Generic Environmental Impact Statement for License Renewal of Nuclear Plants

Supplement 28

**Regarding
Oyster Creek Nuclear Generating Station**

Final Report - Appendices

Figure 3. Oyster Creek Nuclear Generating Station Site Boundary
(Source: AmerGen 2005a)

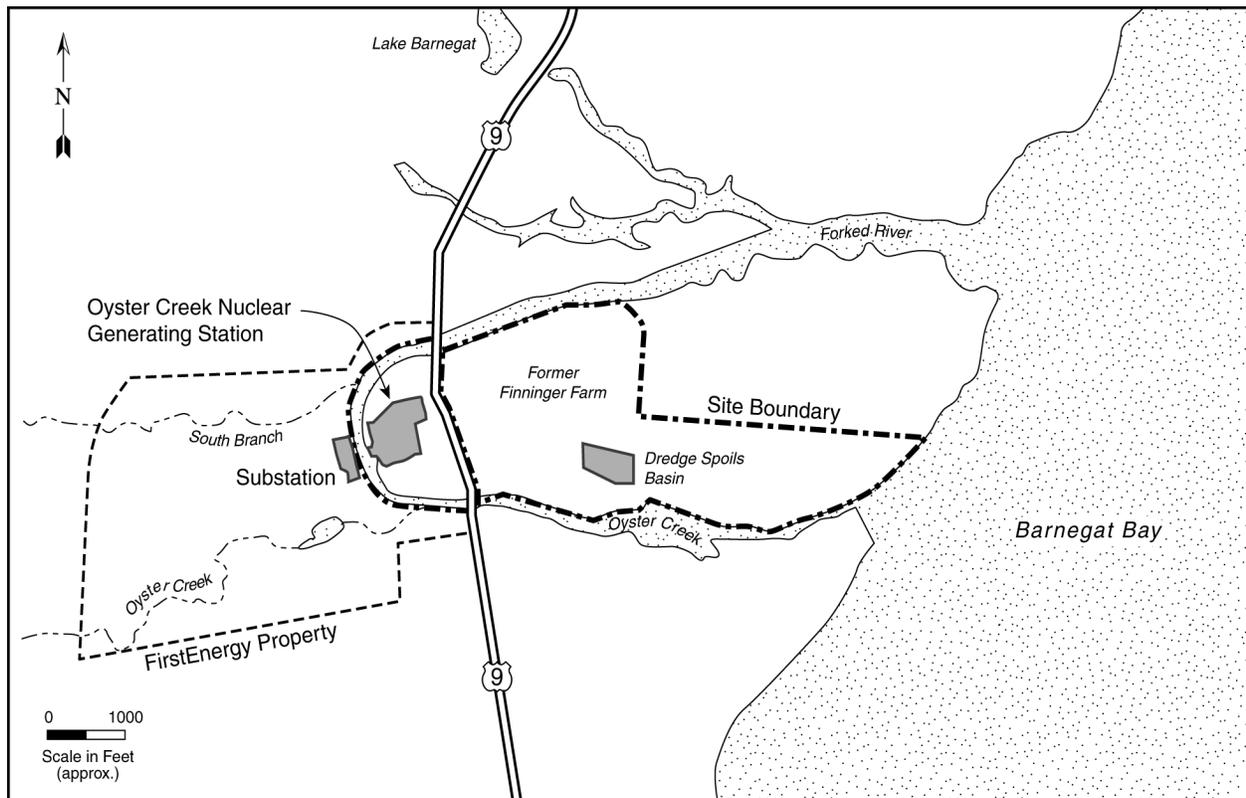
Comment: Figure 2-3 on page 2-4. It's the Oyster Creek Nuclear Generating Station site property map. If you would just take a look at it? You will note that both Oyster Creek and the South Branch of Forked River west of the plant are delineated with dotted lines. Well, I'll tell you what I did. I checked the USGS map plot and brought a copy of it here today. You can clearly see that both Oyster Creek and the south branch of Forked River on USGS quad map are solid blue lines. That may not seem significant, but to an ichthyologist or people that use USGS maps as reference material, the dotted line indicates according to USGS legend an intermittent stream and one that does not carry constant flow of water. At best, this map to me is misleading.

Comment: Figure 2-3 (OCNGS site boundary map), on page 2-4, delineates both Oyster Creek and the South Branch Forked River west of the Station with dotted lines. (Usually, dotted lines indicate watercourses of an intermittent nature). The USGS quad for the area delineates both streams with solid blue lines, well beyond the Garden State Parkway to the west. The NJDEP maps indicate that both streams are watershed of the Pinelands National Reserve. (CC-2)

Response: *The comments point out that the map shown in Figure 2-3 uses dashed lines to indicate the upper reaches of Oyster Creek and the South Branch of Forked River (i.e., those portions upstream of the intake and discharge canals). The commenter correctly points out that dashed lines are conventionally used to indicate intermittent streams. Because neither the*

South Branch of Forked River nor Oyster Creek are intermittent in the area shown on the map, both streams are indicated as solid lines in the revised Figure 2-3 of the SEIS.
